Technical Service Information

FORD 4R44E 2-3 UPSHIFT FLARE

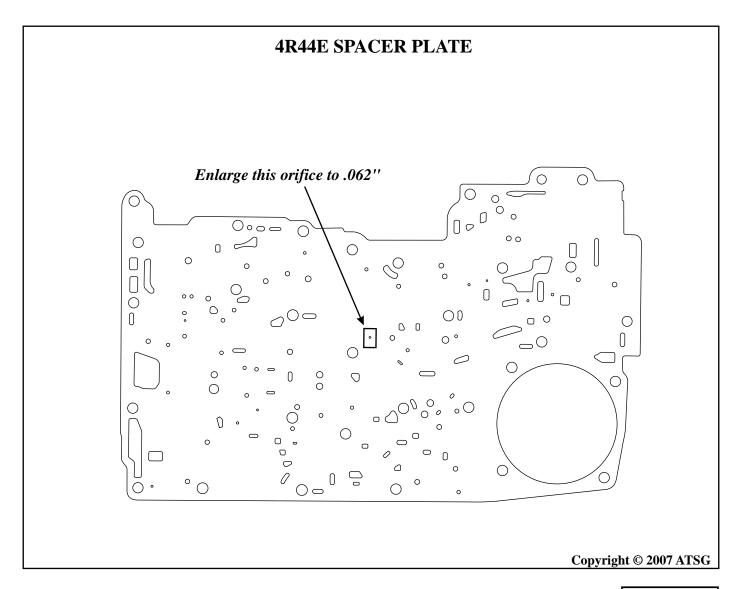
COMPLAINT: Vehicles equipped with the 4R44E transmission, may exhibit a 2-3 upshift flare before or

after overhaul.

CAUSE: The cause may be, insufficient Direct Clutch pressure during the 2-3 upshift transition.

CORRECTION: Locate the orifice, as shown in Figure 1 and enlarge the hole to .062."
